CERTIFICATE OF APPROPRIATENESS
ISSUED: November 15, 2023
EXPIRATION: November 15, 2024

As you are aware, Wednesday evening the Historic Preservation Commission gave Final Design Review approval for the work you are proposing for the George and Annie Spencer House, at 425 E. Elizabeth St.

Responses to Work Session Questions

Address: 425 E. Elizabeth St. (George and Annie Spencer House)

Picture Below: diagram of visual impact of adding a new horizontal element in the middle of the front façade (a guardrail extension shown in RED) versus the visual impact of addition a new horizontal element at the base of the front façade (a raised garden shown in ORANGE)

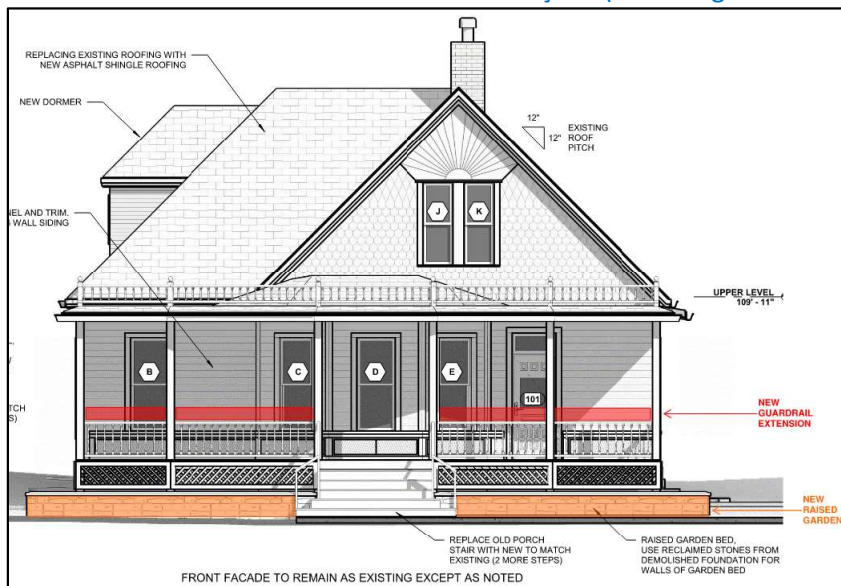
- 3) On packet Page 80, it shows the 1948 Tax Assessor photo of the house, and it appears that the house is quite high up; the commissioner noted this just to recognize that raising the house up may actually bring it back to its original position with respect to the land, but he also recognized the need to conform to modern building code and not impact the porch railing by raising the grade using the proposed garden beds. Would you please explain the choice for the garden bed in greater detail?

- a) (Applicant) Adding guardrail extension on the front of the porch would be more disruptive to the original character of the front façade because it would add a new horizontal element in the middle of the elevation of the house, whereas a new raised garden bed would introduce a new horizontal element only at the base of the house.

PROJECT TITLE: MAIN FLOOR PLAN & LOWER FLOOR PLAN

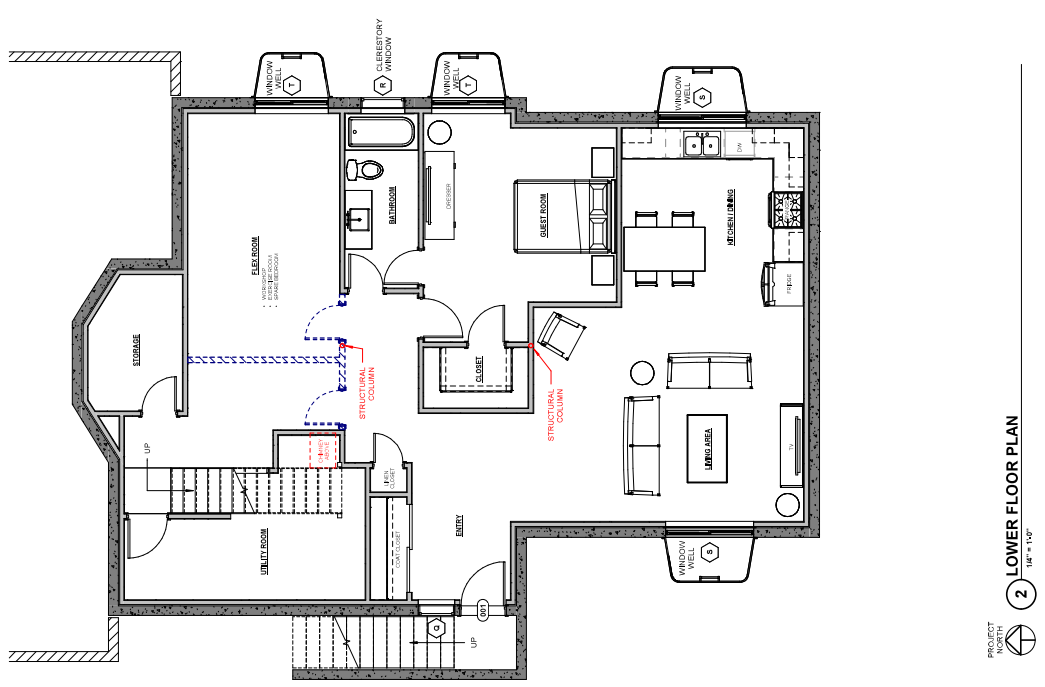
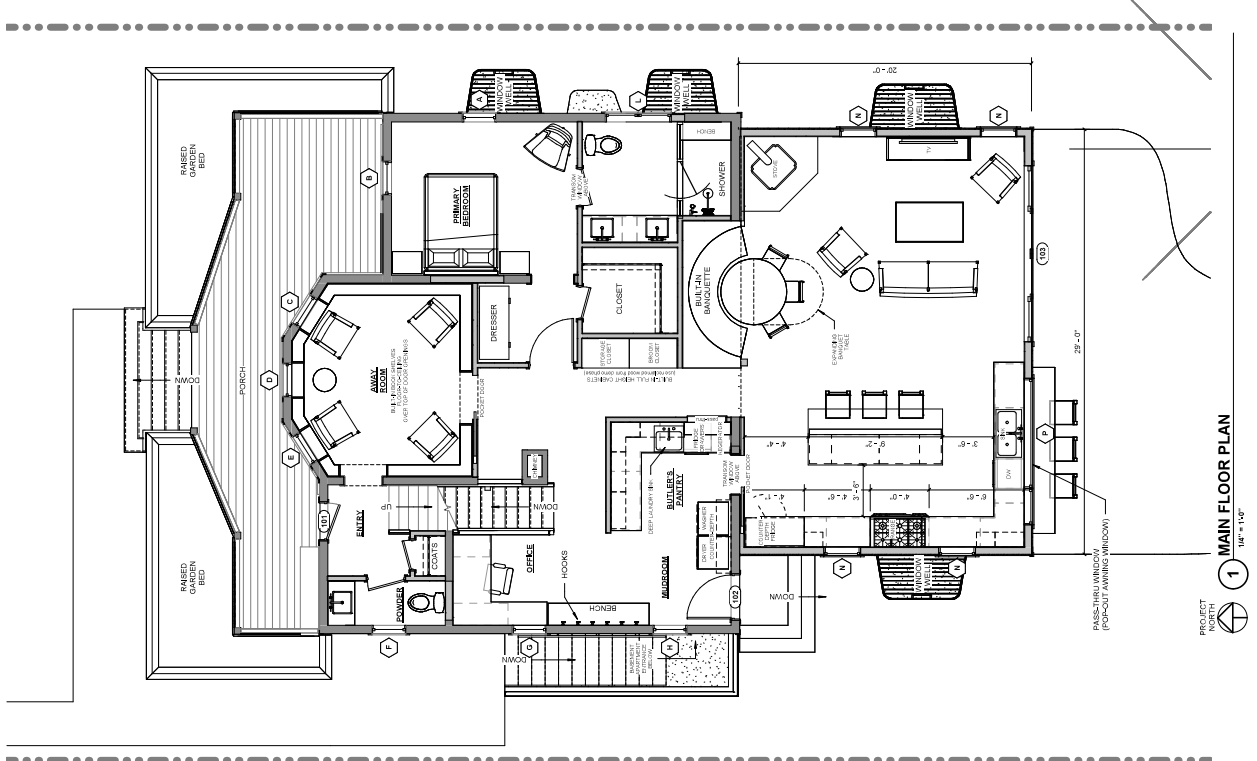
- 1) Would you please add a floor plan of the addition and basement? Just a very basic sketch would do.
 - a) (Applicant) Attached are floor plans of the main level and the basement level.

#2 - Storm windows

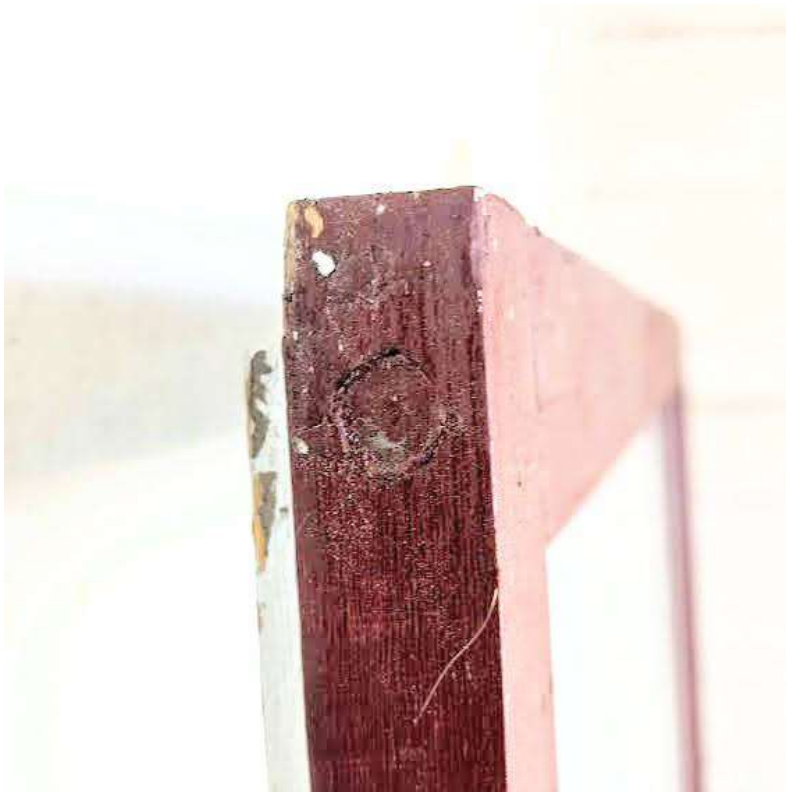
- 2) How do you know the storm windows are not original?
 - a) (Applicant) Attached is a letter from Jeremy Spiegel from Spiegel Restoration concerning his assessment of the window storms.

Based upon my experience and consultation with other window restorationists, I can confidently say that the storm windows at 425 East Elizabeth Street are not original to the house. My primary source for this conclusion is the use of dowel joints for the joinery. Late 19th and early 20th century window makers rarely used this type of joint.

Additionally, if the storms had been sourced at the same time as the windows, they most likely would have been sourced from the same manufacturer. Since the window manufacturer utilized mortise and tenon joinery on the windows, it would make sense that they would utilize the same joinery technique on the storm windows. Therefore, these storm windows are likely not original to the house.

Along with the joinery, the use of mitered molding in place of glazing compound also indicates modern craftsmanship, and not what would be expected from a manufacturer during the late 19th and early 20th century.

#4 - Area context

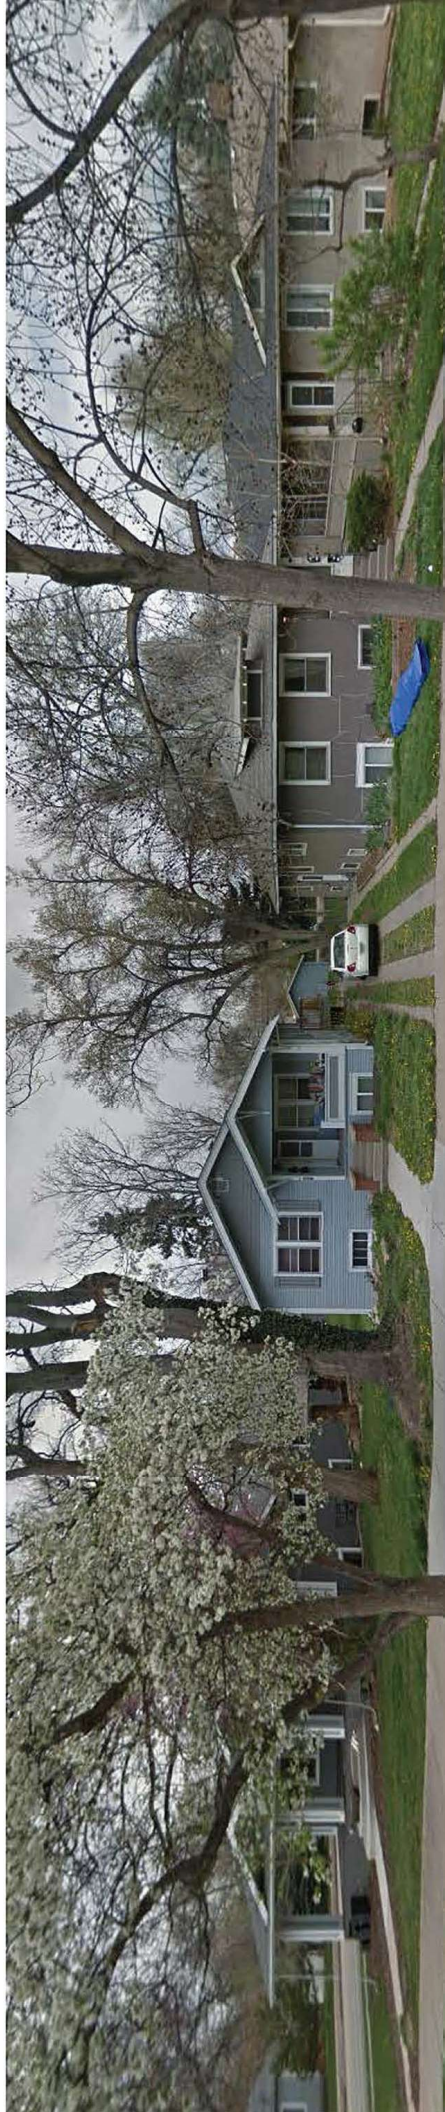
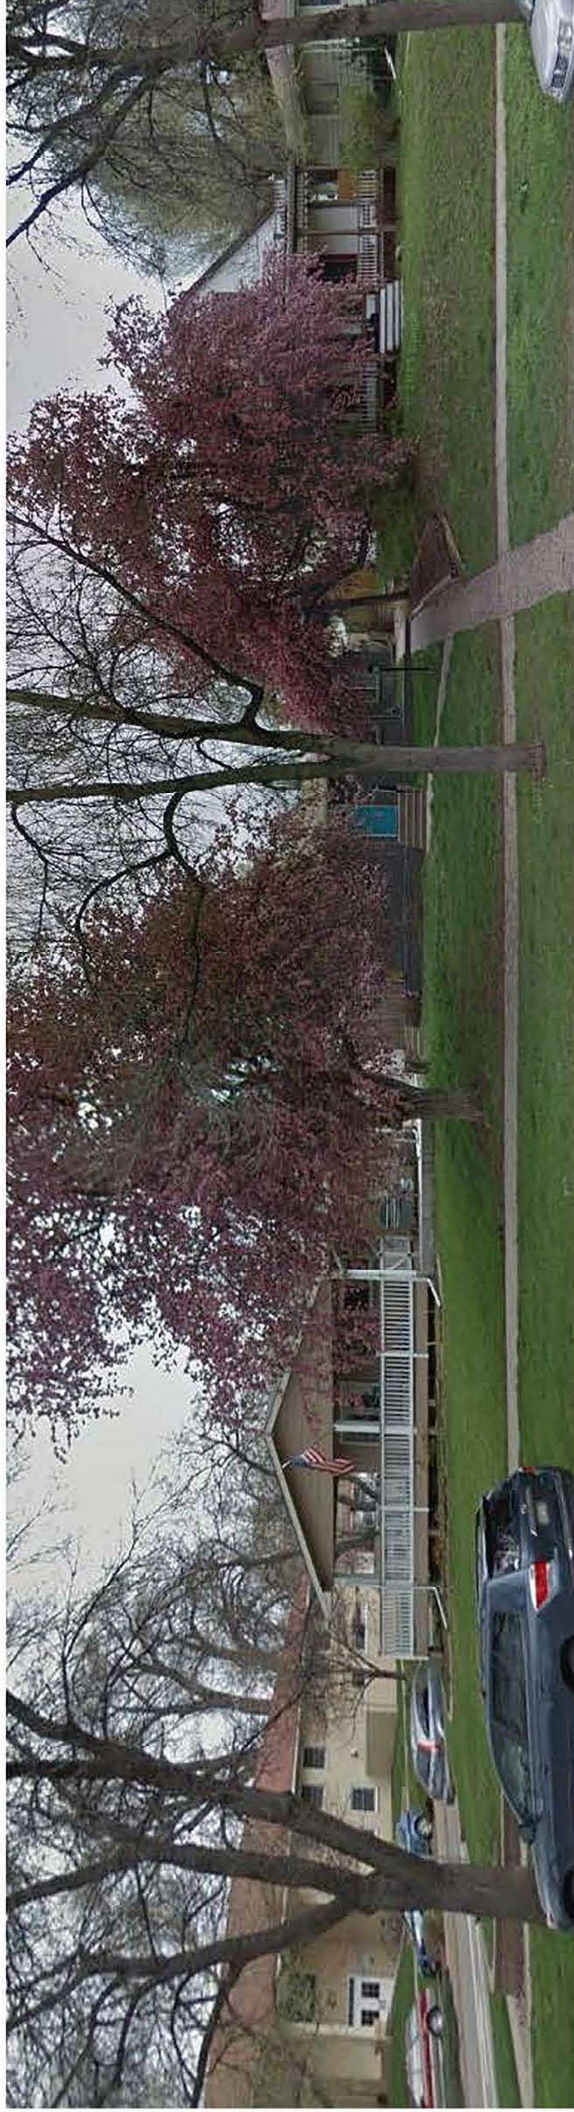
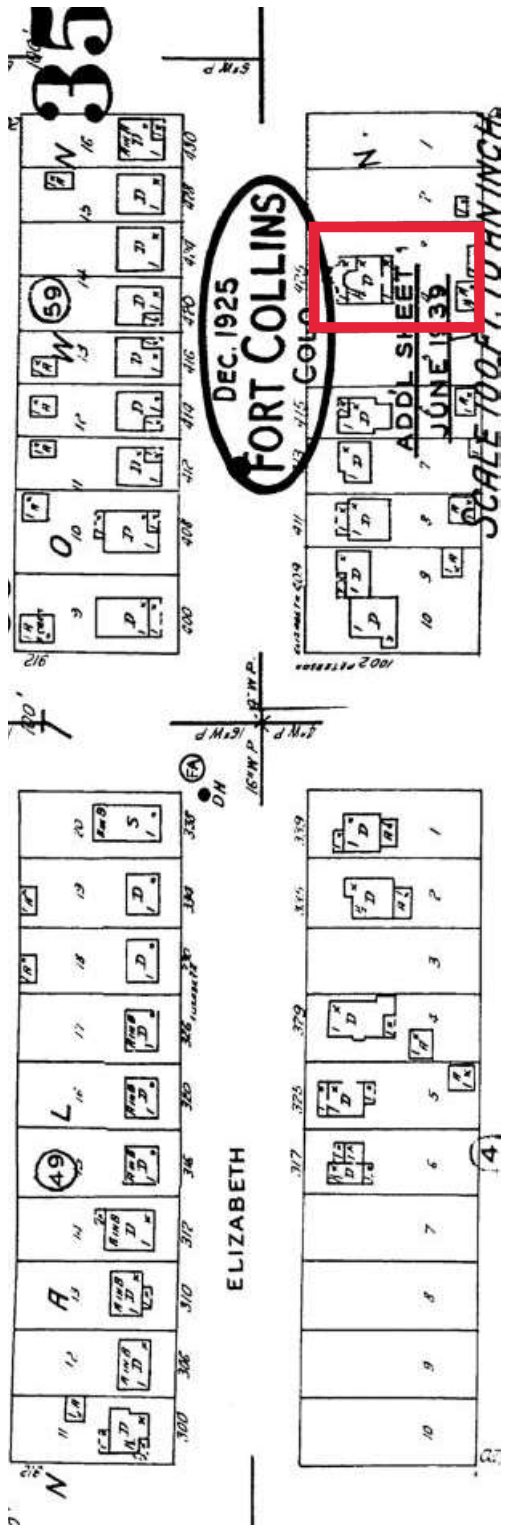
- 4) Concerning raising the level of the house and area compatibility, would you please provide some context related to neighboring houses or nearby contemporaries to this house?

- a) (Staff) Attached are some images of the area surrounding 425 E. Elizabeth St., with captions noting the year built and number of stories of each building (Tax Assessor data). The last page of the attachment is the 1939 Sanborn Fire Insurance Map showing the 300 and 400 Blocks of East Elizabeth Street.

DORMER ADDITION

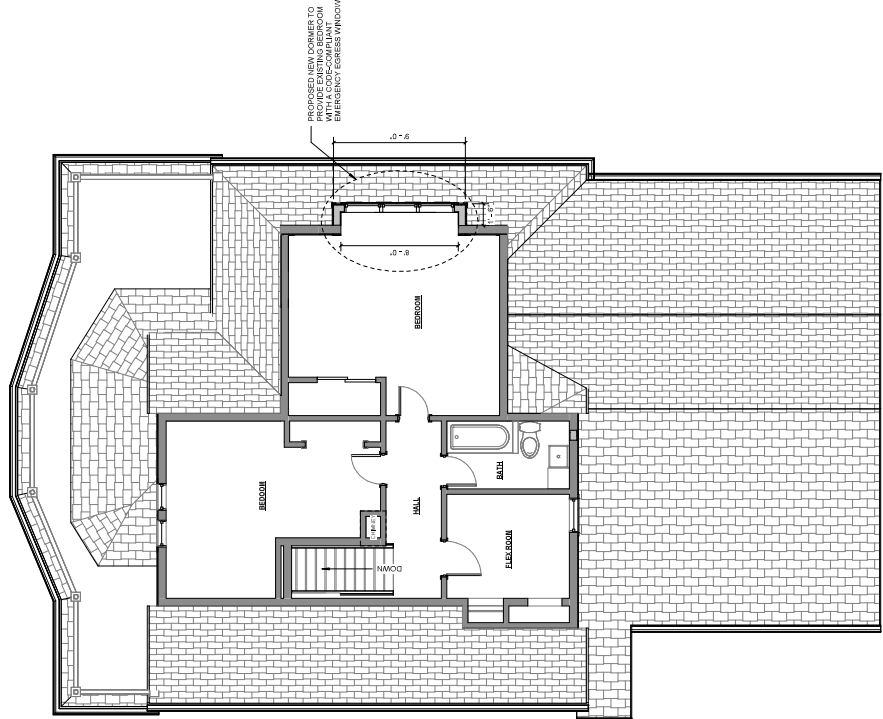
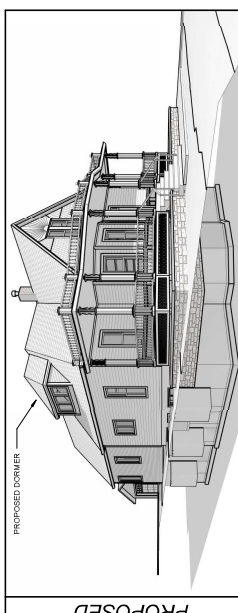
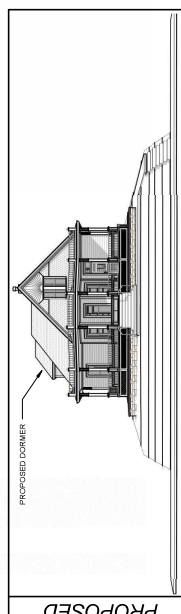
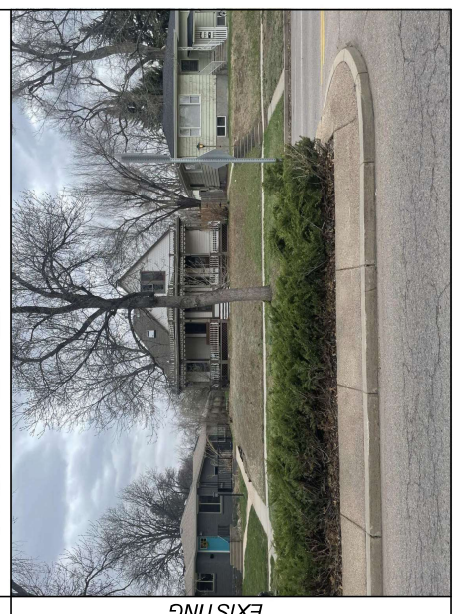
- 5) The applicant noted that the dormer is not the smallest it could be for egress, but what about the code requirements for light and air? Would you please provide some information about that in relation to the size of the proposed dormer?

- a) (Applicant) Regarding the dormer size, there is a minimum amount of glazing and ventilation required for a habitable space: 8% glazing area of the total area of the room and 4% ventilation area of the total area of the room (IRC 303.1). The bedroom has 155 sq ft of floor area and therefore the minimum amount of glazing must be 12.4 sq ft. The glazing in the dormer we proposed in the drawings we submitted on October 20th is only 8.7 sq ft. We'd like to propose adding a third fixed window between the two casements windows for a total 13 sq ft of glazing. We'd widen the dormer structure an addition 16" to make room for the wider window. (Please see the attached PDF.) This is the smallest allowable dormer size to meet the minimum glazing requirement for a habitable space. The minimum amount of ventilation must be 6.2 sq ft and the proposed windows would have about 9 sq ft of ventilation, meeting the minimum code requirement.
